Service Bulletin: SNX-SB-001

Subject: Identification, Upgrade or Replacement of Rudder Pedals

Model Affected: All Sonex Aircraft with SNX-C02-01 Rudder Pedal Assemblies

Figure A Identification of SNX-C02-01 Rudder Pedal Assemblies

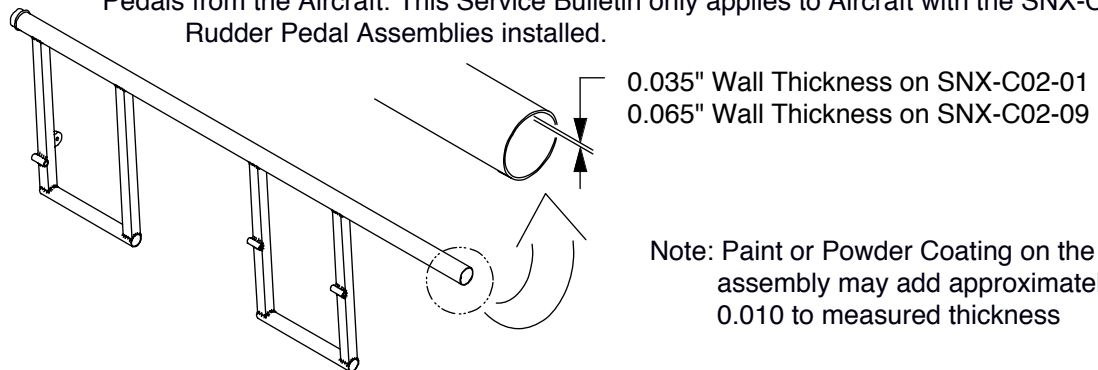
Identification: The SNX-C02-01 Rudder Pedal Assemblies were called out on the Sonex Aircraft for Plans Numbers 001 through 456. Additionally, All Sonex factory welded Rudder Pedals delivered prior to 07 June 2002 were SNX-C02-01 Rudder Pedals. The SNX-C02-01 Rudder Pedal can be distinguished from the SNX-C02-09 Rudder Pedals by the 0.035" wall thickness of the main tube for the SNX-C02-01 Rudder Pedal Assembly rather than a 0.065" wall thickness of the SNX-C02-09 Rudder Pedals as depicted in Figure A. The measurement of the Rudder Pedal main tube wall thickness requires the removal of Pedals from the Aircraft. This Service Bulletin only applies to Aircraft with the SNX-C02-01 Rudder Pedal Assemblies installed.

Figure B Inspection of Rudder Pedal Assembly

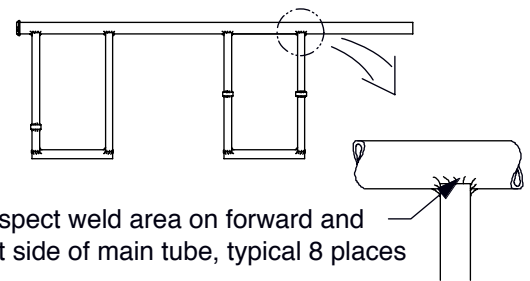
- 1.) Tag to identify the forward and aft Rudder Pedal Assemblies, Remove the Rudder Pedal Assemblies.
- 2.) Inspect the areas shown in Figure B with a magnifying glass for any cracks, deformation or other distress. Any cracks, deformation or other distress renders the assembly unservicable and it must be replaced.
- 3.) Upgrade the Rudder Pedal Assemblies per page 2 of this Service Bulletin by adding the tube, straps and spacers
- 4.) Reinstall the upgraded Rudder Pedal Assemblies in the Aircraft per the SNX-C01 Drawing ensuring that each Pedal Assembly is returned to it's original position.
- 5.) Check to ensure that full rudder travel is available without interference on the Pedals.
- 6.) Enter in Aircraft Log book that Service Bulletin SNX-SB-001 was complied with per Method A.
